Pine Point Residents Association

**Residents' Comments Concerning
Beach Access Plan
Pine Point
For Planning Board Consideration
March 15, 2010**

Pine Point Beach Access
Preliminary Concept Plan For Public Discussion

STONE WALL STRUCTURE ENCROACHMENT

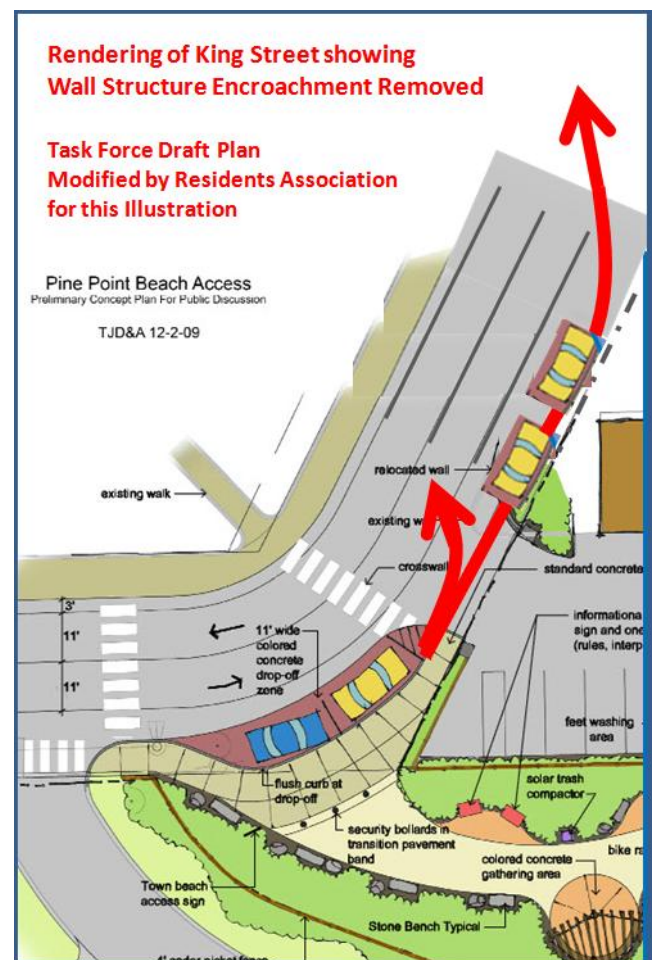
1. Residents have had safety concerns about the stone wall structure built by the motel since it was installed many years ago.
2. The structure requires pedestrians and cyclists to use the travel lane at a heavily traveled area just beyond a curve.
3. It is NOT a typical encroachment common in the Town's rights-of-way. This structure is not a tree or bush, a small picket fence or set of mailboxes. It is a stone wall, backfilled and landscaped... almost entirely on Town Land. It held lighting and signs which obviously violated the setback requirements.
4. Recent surveys finally presented the undeniable fact this very large structure lies almost entirely on town property.

5. Residents worried the engineer brought on late in the process would endorse the Town's long-held position and suggest the stone wall remain. His recommendations are unclear. Common sense, however, should prevail. If engineers were infallible there would be no need for Task Forces or Planning Boards.

6. The Planning Board also expressed concerns about the wall when they reviewed the motel's parking lot site plan last month. It must go. That was overwhelming resident sentiment. It is a matter of safety, equity and fairness.

BENCHES

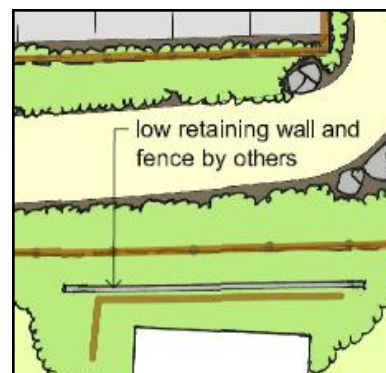
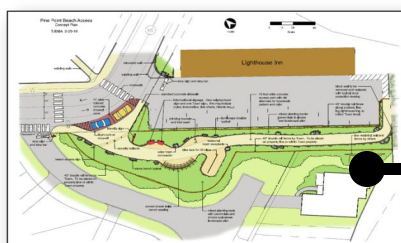
Agreed, although the height should vary to accommodate seniors.

Response to Mr. Bray's Report to Task Force: Sign Removal

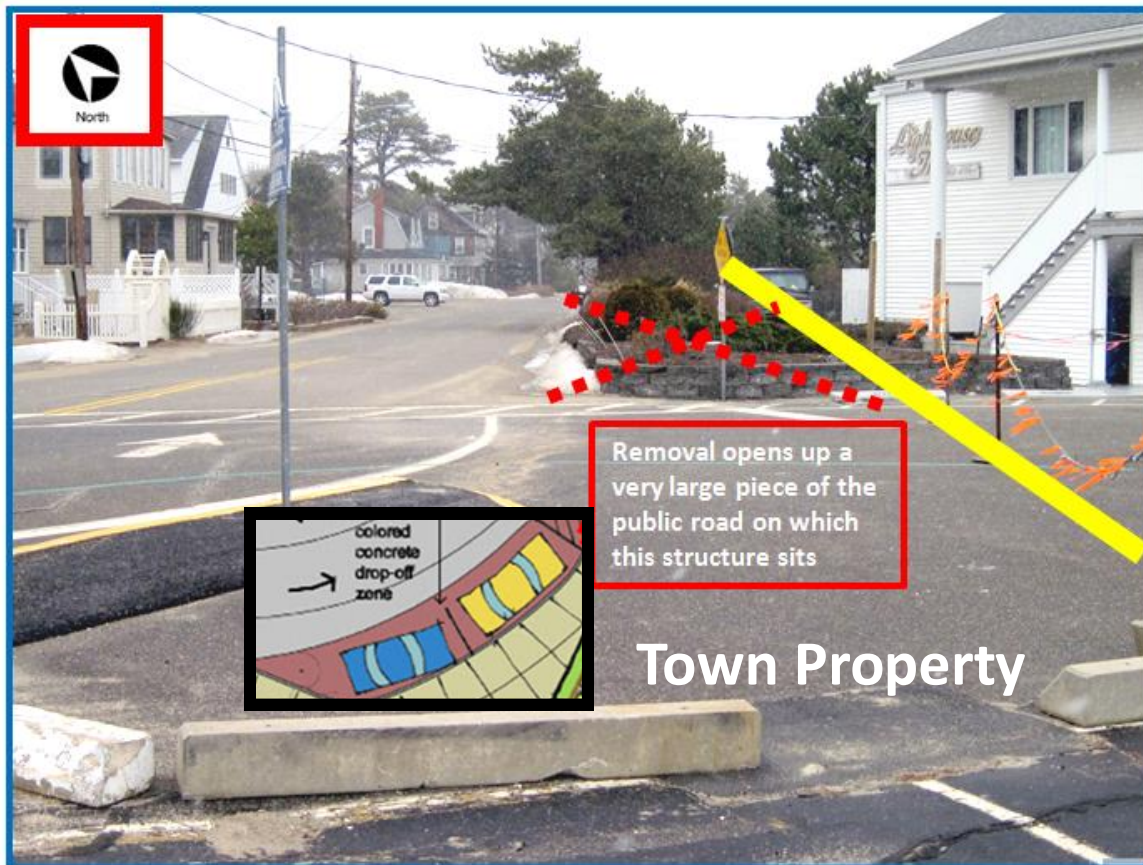
Association leaders and members reviewed the report and concluded Mr. Bray did not specifically address the questions posed by members of the public at the forums regarding removal of the encroachment of the stone wall structure in the right-of-way. Several residents' positions were that removal of the encroachment would enhance pedestrian safety regardless of any other improvement in this area because its presence forces pedestrians to walk in that section of King Street just after the curve. Bray's reference to "visual delineation aids" is unclear, but the question from residents related to the extent to which removing the encroachment would make for a more practical and safer drop-off plan as shown later in this report.

Residents believe removal of the structure would open up a significant area of the right-of-way and provide safer drop-off and maneuvering back on to King Street (see red arrows showing the wall gone and a more gradual return of cars on to King Street. It also affords the opportunity to continue the sidewalk-esplanade design.

Finally, Bray's conclusion (#5) regarding the business parking sign across from the Truman's stone wall encroachment (see graphics) just reinforces residents' opinions. He wrote "**King Street is a somewhat narrow roadway;**

Removal of Stone Structure From the Street to the Property Line (yellow line) will open a large area of the right-of-way which has forced pedestrians into the street for years. It will also facilitate a safer drop off and potential for extending the sidewalk-esplanade design.

Rendering of King Street showing Wall Structure Encroachment Removed

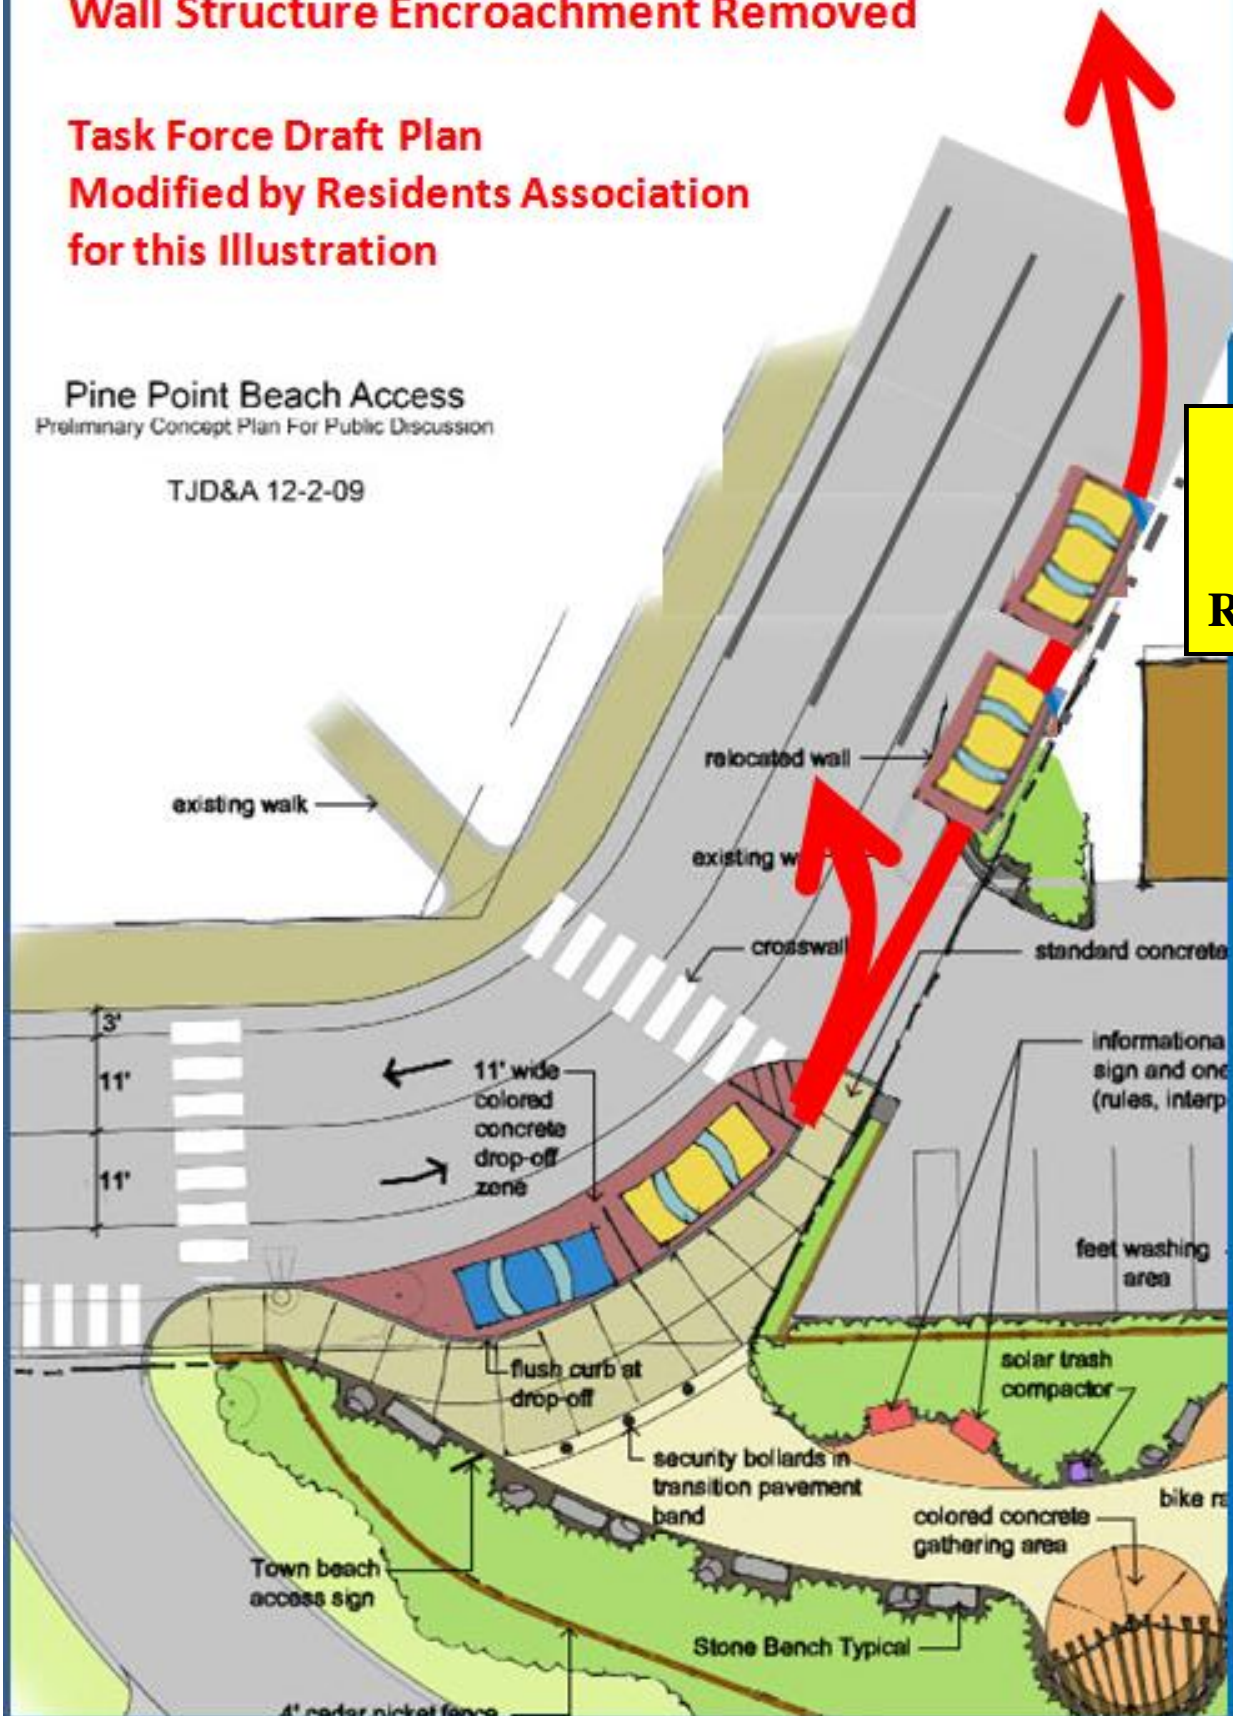
**WALL
IN
ROW
REMOVED**

Bill Bray
Notes in Red

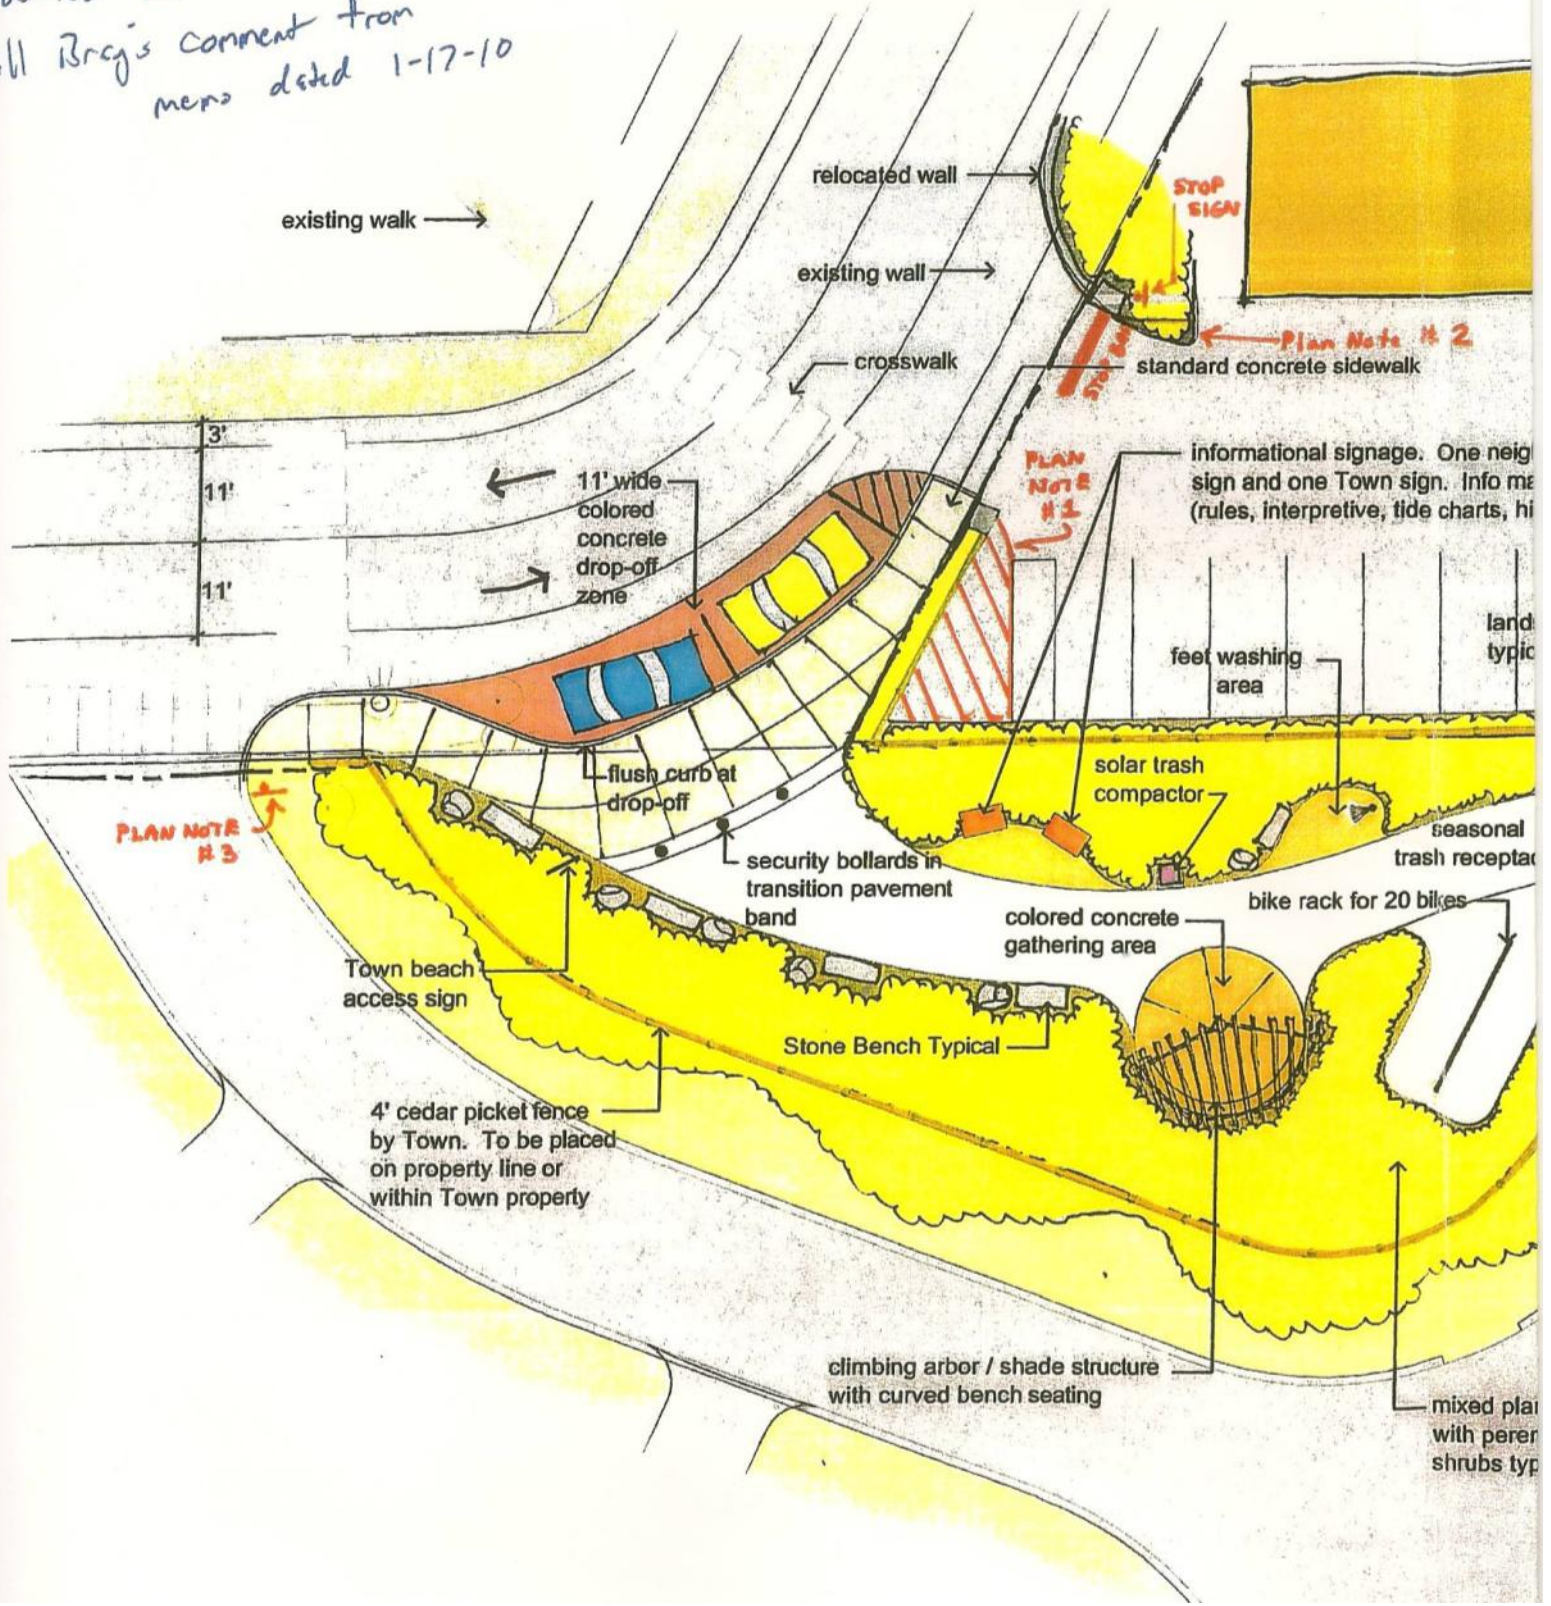
1. It would be most desirable if the Town can influence three changes to the parking area fronting the Lighthouse Inn: A stop sign and stop bar should be added at the entrance of the parking lot controlling exiting movements from the lot. Additionally, immediately upon entering the parking lot from Pine Point Road the triangular area bordering the concrete sidewalk and the handicap parking space buffer area within the Lighthouse Inn parking lot should be defined as a no-parking area, preferably as a raised landscaped area or, at minimum, with flush/colored concrete to insure this area isn't used for parking. I have labeled this area on the attached marked up plan as note #1.

2. Proposed modifications to the existing landscape wall that fronts the Lighthouse Inn property along King Street, in combination with the proposed painted "fog" line that extends through the horizontal curve connecting Pine Point Road to King Street, are critical visual delineation aids for motorist traveling between the two streets. It may be desirable to soften the curb radius at the entry point to the parking lot. Refer to note #2 on the attached plan

3. A standard stop sign should be installed at the intersection of the private residential street and Pine Point Road. Refer to note #3 on the attached plan.

4. Motorists utilizing the proposed parking drop-off area, in circulating to/from these spaces, will delay traffic traveling along Pine Point Road/King Street for short periods of time simply because of the narrow widths of both roadways. Although, the length of delay should be very minimal and have limited impact on traffic circulation throughout the neighborhood. Clear parking space markings should be included as a feature of the design to ensure that no more than two vehicles are parked at any given time. A third vehicle attempting to park within the designated area would likely encroach on either of the two pedestrian crosswalk areas, from a safety perspective, an undesirable result. Predictable enforcement of the defined parking regulations for these spaces will ensure the success of their utilization by the public.

5. An existing sign located along the northwest side of King Street implies that short duration business parking is allowed. It is suggested that the sign and parking designation be eliminated. King Street is a somewhat narrow roadway; on-street parking on either side of the street, even for short periods of time, certainly has a negative impact on both vehicle circulation and roadway safety.
